CITY OF ALBUQUERQUE

**RE: 1510 John St
Grading and Drainage Plan
Engineer's Stamp Date: 12/29/25
Hydrology File: L14D071
Case # HYDR-2025-00460**

Based upon the information provided in your submittal received 01/06/2025, the Grading and Drainage Plan **is not approved** for Grading Permit and Building Permit. The following comments need to be addressed for approval of the above referenced project.

LOT 11, BLOCK L, EASTERN ADDITION 1510 JOHN STREET GRADING AND DRAINAGE PLAN	DRAWN BY MM DATE 12-29-2025
	Rio Grande Engineering P.O. BOX 83824 ALBUQUERQUE, NM 87199 (505) 321-8099	SHEET # C1 JOB #
12/29/25 DAVID SOULE P.E. #14522

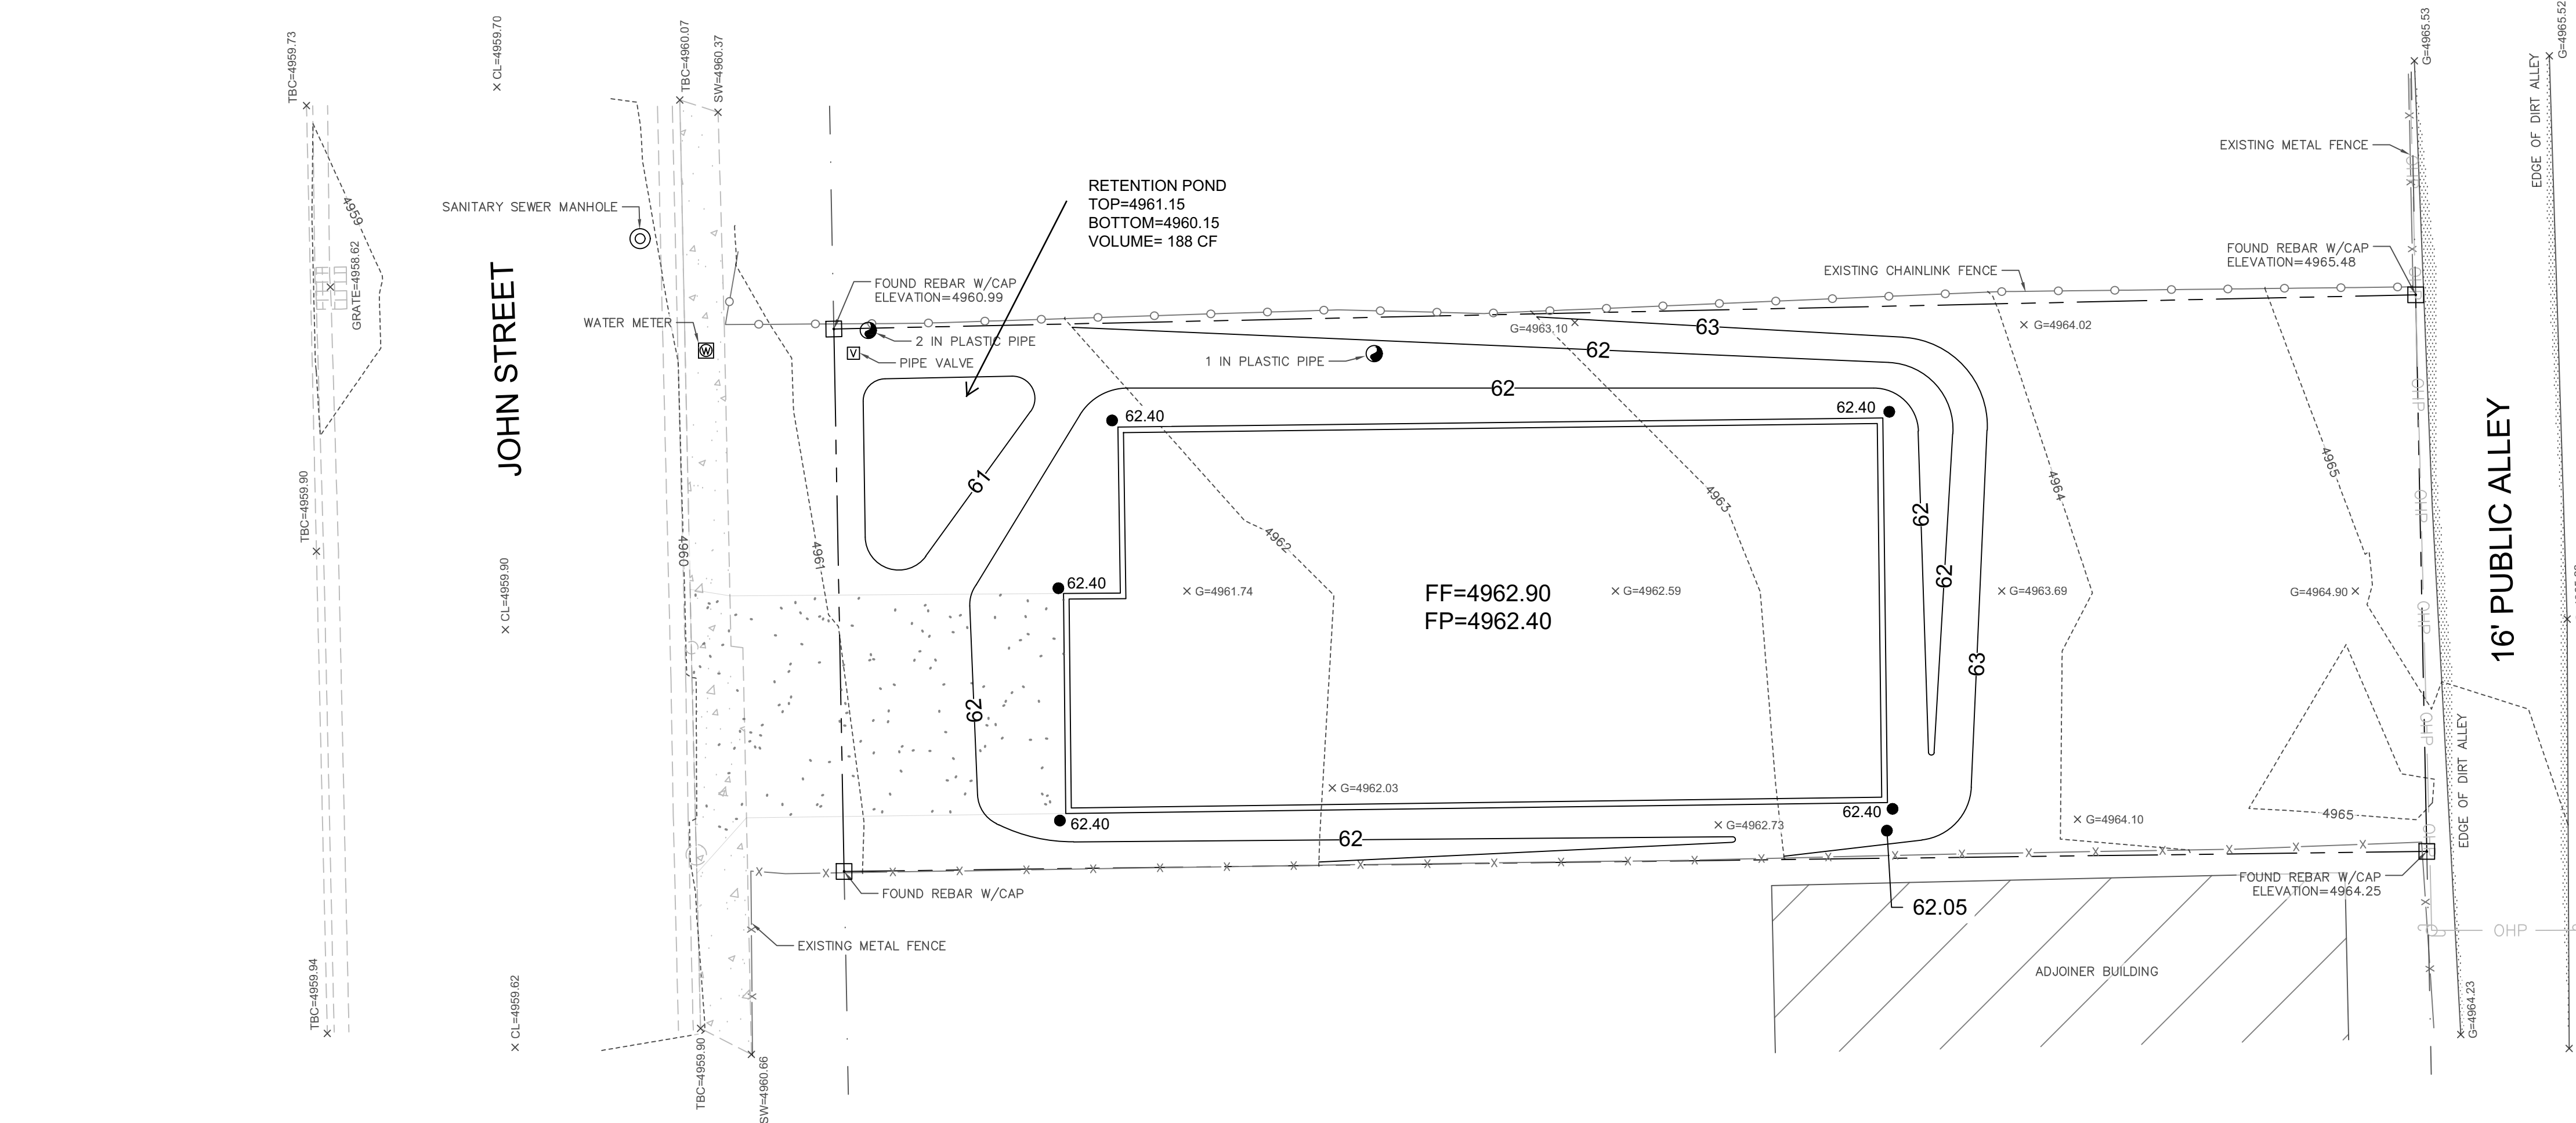
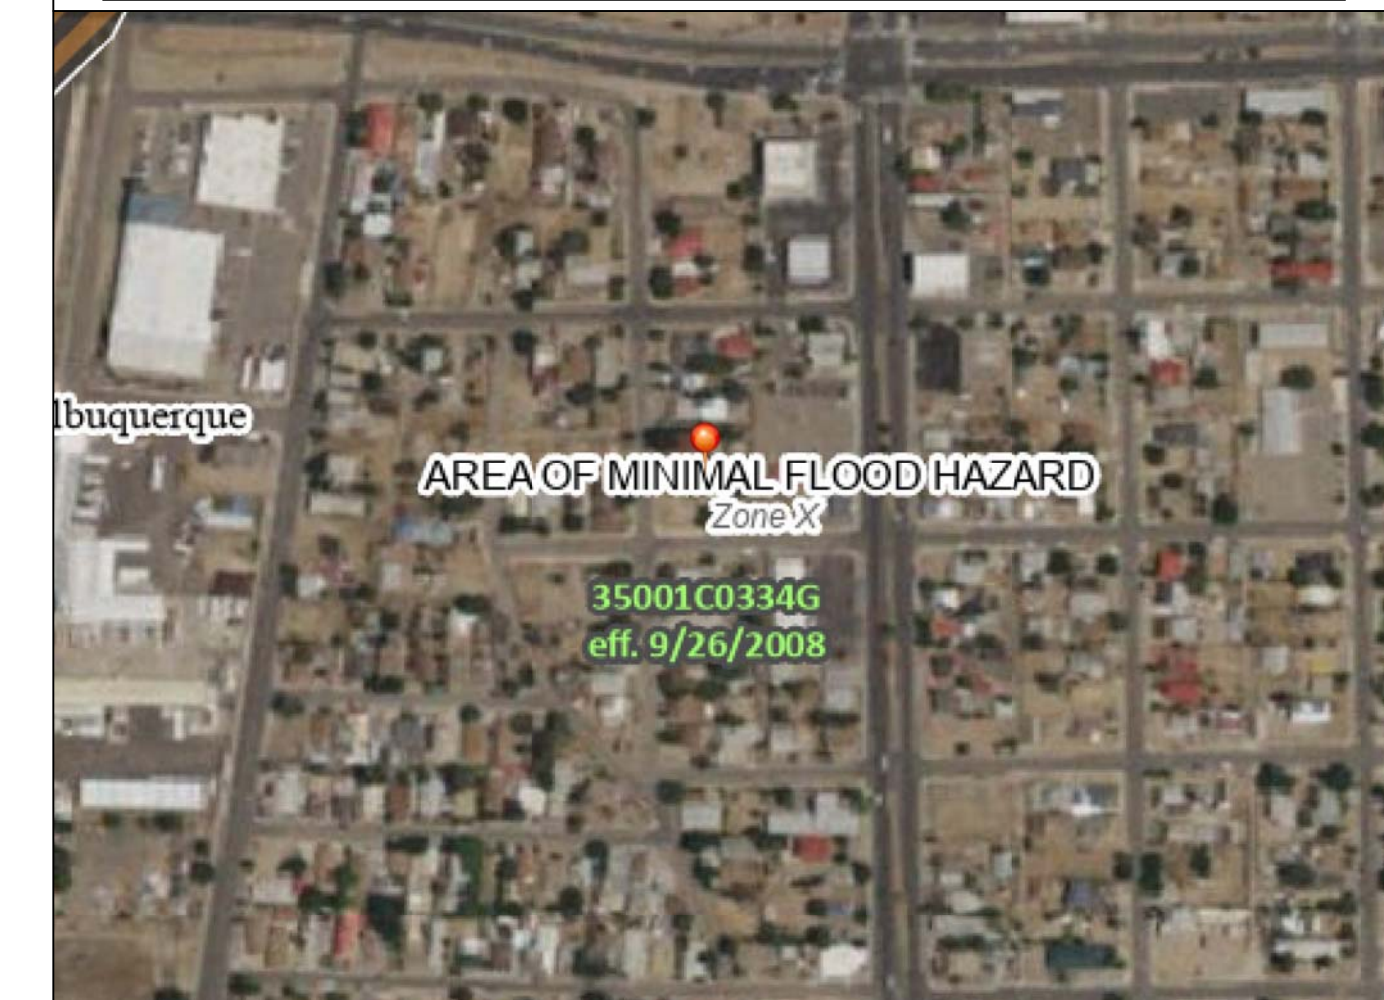
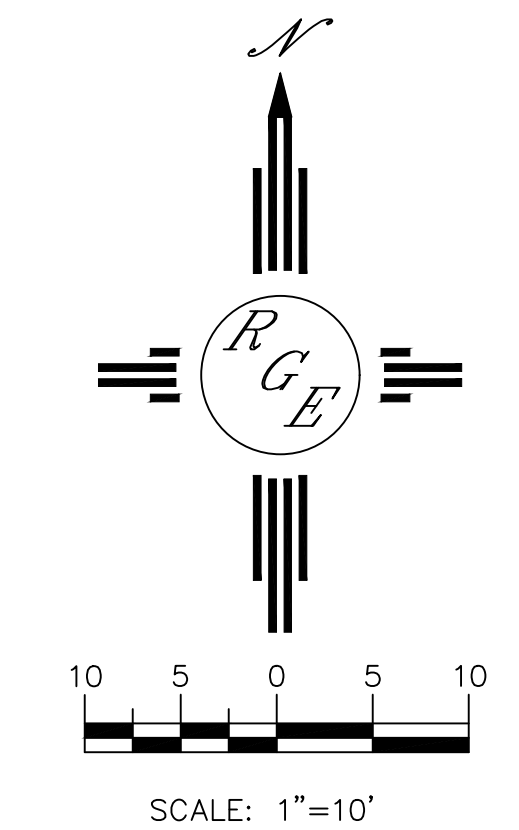
1. Zone 1 constants were used for calculations, please revise and resubmit using Zone 2 constants.
2. Since this site is in the Valley region, please follow Article 6-5 Valley Drainage Criteria of the DPM. The following conditions must be applied to the site:
 - a. A permanent perimeter wall or barrier on the North and South side of the development is required to contain the 100 year, 24-hour storm developed runoff.
3. Show swales clearly in the plans.
4. Show where the roof drains are located and where they will drain to.
5. Show the emergency pond overflow directed towards the driveway.
6. Please provide the FIRM Map floodplain note with effective date.
